WESTERN GREENBRIER CO-PRODUCTION DEMONSTRATION PROJECT

FINAL ENVIRONMENTAL IMPACT STATEMENT COMMENTS AND RESPONSES ON THE DRAFT ENVIRONMENTAL IMPACT STATEMENT

DOE / EIS-0361

NOVEMBER 2007

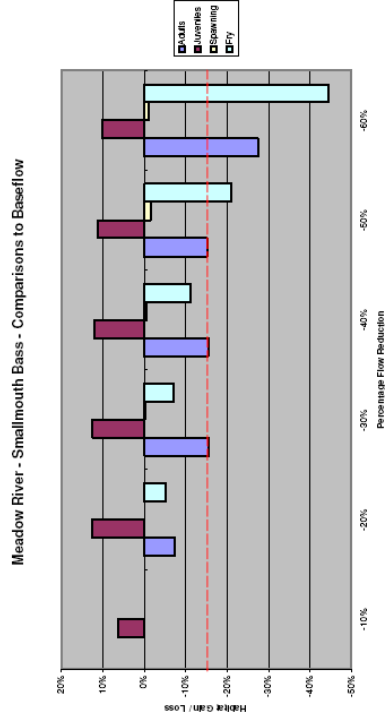
life stages. Indeed, if all life stages are not equally supported under a given flow regime, one can assume that the ultimate effect will be to decrease the population success of that species. Thus, in the case of the smallmouth bass, for example it might be possible that decreases in flow might improve habitat for the juveniles and fry but provide significant loss of habitat for adults (see below, when comparing flow reductions from mean daily flows [in this case, there is a significant loss of adult habitat at a reduction of 20% and a concurrent increase in habitat for juveniles and fry while there is no impact to spawning, production of fry and juveniles, and the ultimate decline or loss of the population, regardless of the availability of improved habitat for other life stages. (Gore report p. 8)

(Gore report p. 10)

Meadow River - Smallmouth Bass - Mean Daily Flow

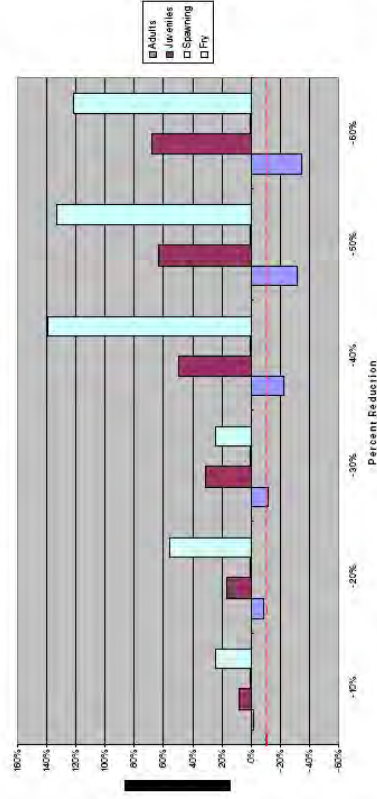
Here the *relative impacts* are far greater even though the withdrawals are actually of less volume.

Reductions from base flow will also significantly impact recreations opportunities.

Meadow River - Recreational Boating - Comparisons to Baseflow

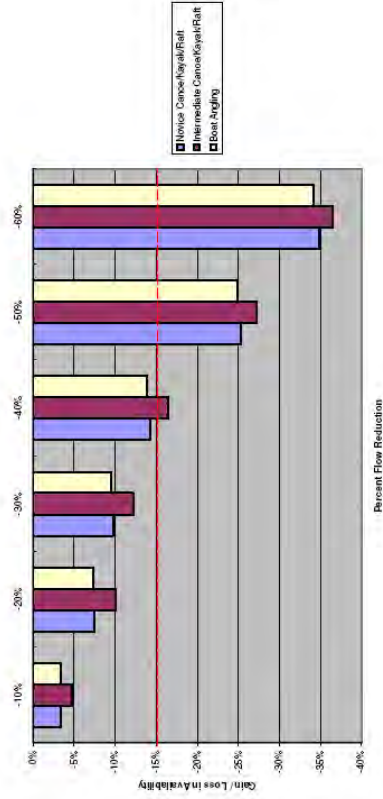
As is seen in the graph above (Gore report p. 13) intermediate boating will be significantly impacted as compared to that use at base flow as will other types of boating activities. While useful, the above graph compares recreational uses at base flow vs. the planned withdrawals below baseflow. The graph does not show the loss of use as compared to total actual flow.

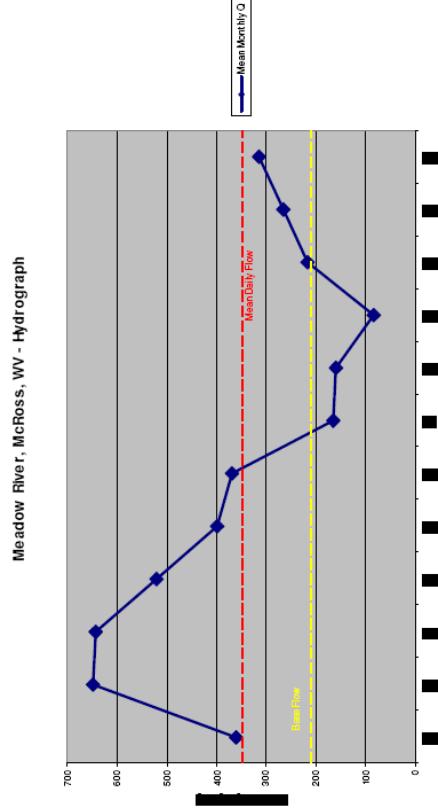
The hydrograph below (Gore, Meadow Comparison) helps to understand that comparison by showing the relationship between base flow (i.e. ground water contributions) and mean daily flow and mean monthly flow (closer to actual flow).

The 40% withdrawal from base flow discussed in the DEIS (p 4.4-10) would result in a river flow of approximately 120 cfs (40% of 200 cfs). It is important to compare that reduced flow, 120 cfs, not only to base flow but actual river flow as demonstrated in the graph above.

Commenter 92 – Margaret Janes
Meadow River - Recreational Boating

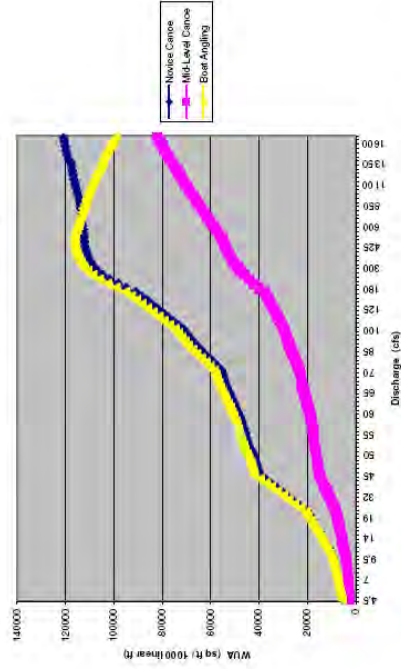
The graph above (Gore Meadow WUA) shows weighted usable area (WUA) for boating at different flows. At 120 cfs the WUA is approximately 33,300 (mid) and 80000 (novice/fish) sq ft/1000 linear ft. But the Meadow River ordinarily flows at rates of equal to or greater than 350 cfs at least 6 months of the year. At 350 cfs the WUA for boating would be 51,500 (mid), 110,000 (novice) and 114,000 (fishing) sq ft/1000 linear ft. This translates to, **at a minimum, a 35%, 27%, and 30% loss in WUA** over existing conditions for 6 months out of the year if the 40% withdrawals occurred as planned. The loss in usable area for recreation would obviously translate into a loss of actual recreation use and associated income.
